Technical Service Bulletin

HARD SHIFTING/SHIFT LEVER VIBRATION

Bulletin No.: 05-004/20

Last Issued: 07/17/2020

Location of Transmission Related Parts

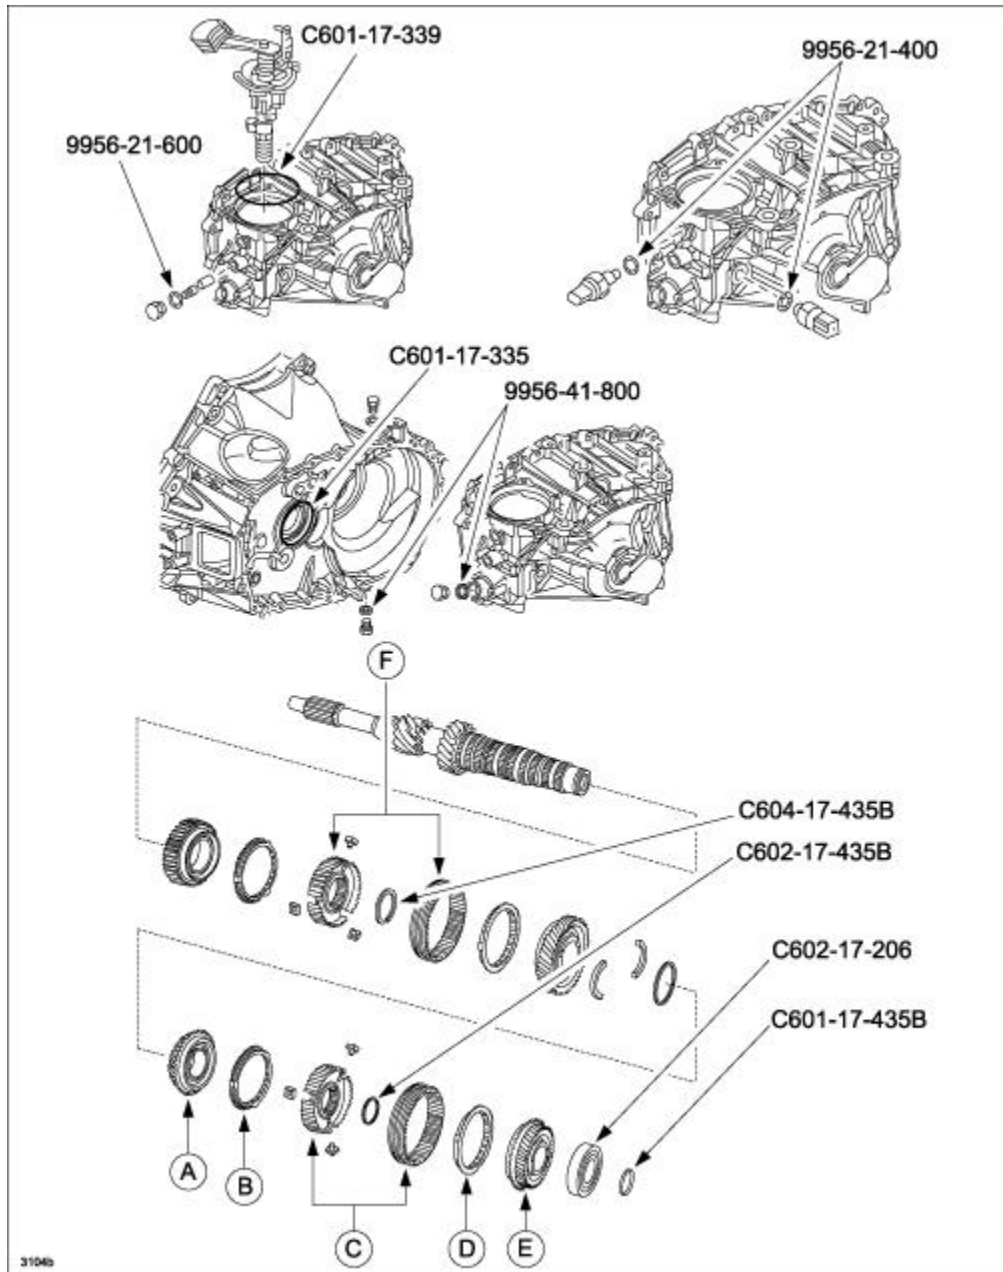
Modification	Subject Part	Changes	Subject Concern
A	3-4 Clutch Hub	Surface Treatment	Jumping out of gear
B	3-4 Clutch Hub 5-6 Clutch Hub	Shape	Hard shifting into 3rd, 4th, 5th and/or 6th gear
C	3rd and 4th Gears	Tolerance	Shift lever vibration
D	3rd and 4th Gears 3rd and 4th Synchronizer Rings	Shape	Hard shifting into 3rd and/or 4th gear (additional improvement)

NOTE: Refer to the following illustrations for the parts location. Confirm the part numbers in the GEPC for the subject VIN and place an order for the corresponding (modified) service part.

Parts Number	Description	Qty.	Notes
C602-17-240B	3-4 Clutch Hub Assembly	1	
C602-17-26YB	Synchronizer Ring	2	
C602-17-620C	5-6 Clutch Hub Assembly	1	Combination 1: Only when C602-17-620C is available (Use current Synchronizer Ring C604-17-26YB)

-	Synchronizer Ring	0	
C602-17-620D	5-6 Clutch Hub Assembly	1	Combination 2: Only when C602-17-620D is available
C614-17-26YA	Synchronizer Ring	2	
C601-17-230D	3rd Gear	1	Part numbers of gears are different depending on the variation of the gear ratio. Check EPC for the correct part number for the repair VIN.
C610-17-230C			
C601-17-210E	Gear, Main Drive (See note below)	1	
C603-17-210B			
C613-17-210B			
F401-17-313	Reamer Bolt	6	Replacement parts that are necessary for all repairs.
C601-17-435B	Retaining Ring	1	
C604-17-435B	Retaining Ring	1	
D602-17-435B	Retaining Ring	1	
C602-17-206	Ball Bearing	1	
C601-17-339	“O” Ring	1	
C601-17-335	Oil Seal	1	
9956-21-400	Washer	2	
9956-21-600	Washer	1	
9956-41-800	Washer	2	
0000-77-5W80-QT	Manual Transaxle Oil	3	Specification: 2.6 - 2.7 US qt
